## Steering - Squeaking Noise Turning Steering Wheel

Order No.: P-B-46.10/19

Model 210.082/083/282

Squeaking Noises When Slowly Turning The [Steering Wheel](#) and Engine is At Operating Temperature

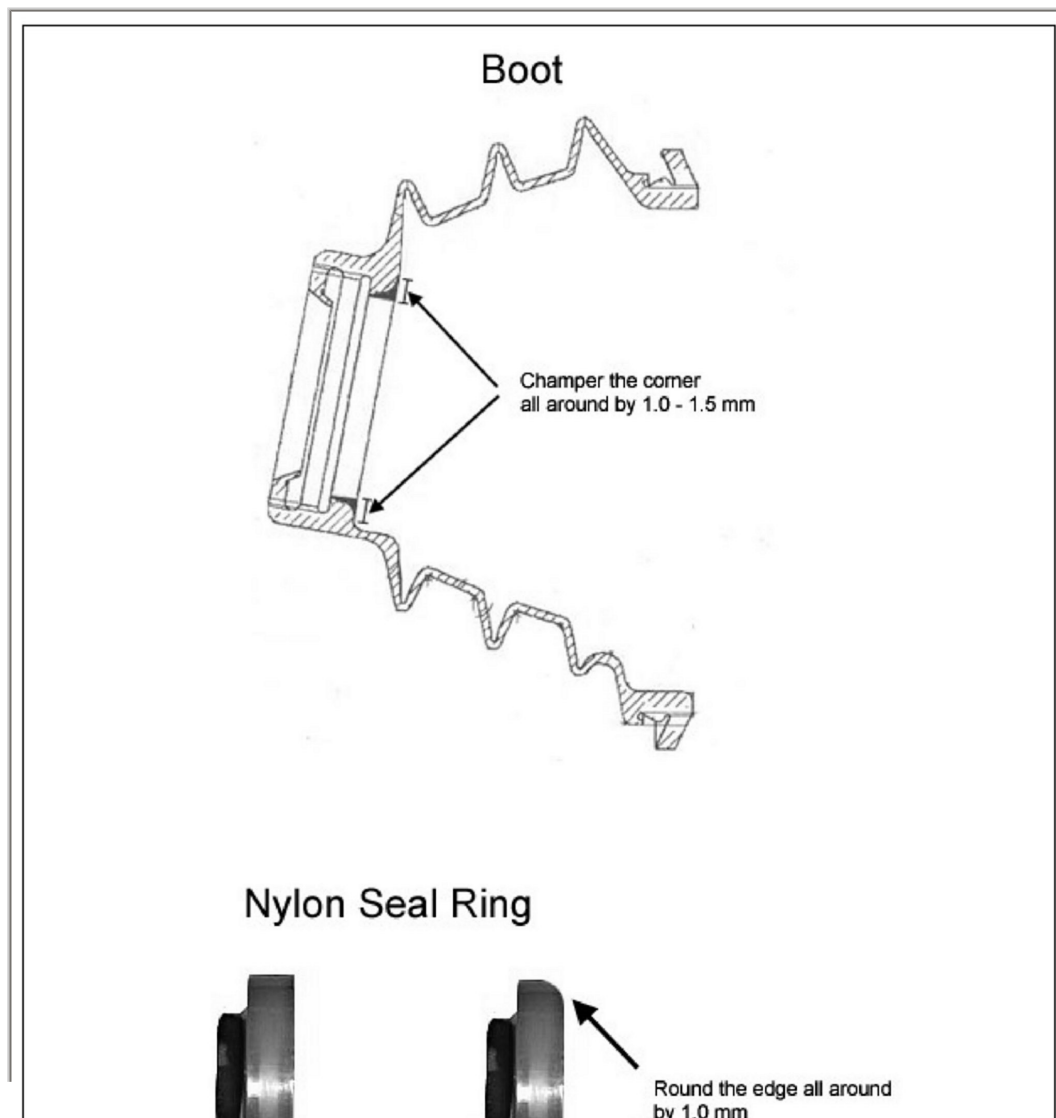
If you receive customer reports in the above model vehicles of squeaking noises while slowly turning the [steering wheel](#) when engine is running at operating temperatures, locate the source of the noise. If the noise is coming from the sealing boot between the firewall and [steering shaft](#), the boot and the seal ring must be modified (Figure 1). Lubricate and re-install the modified boot and seal ring.

**Note:** Existing boot and the seal ring can be modified. After modifying these parts per Figure 1, lubricate the existing modified boot with grease part number A001 989 84 51 10 on both sealing surfaces of the boot (inside and outside the front bulkhead).
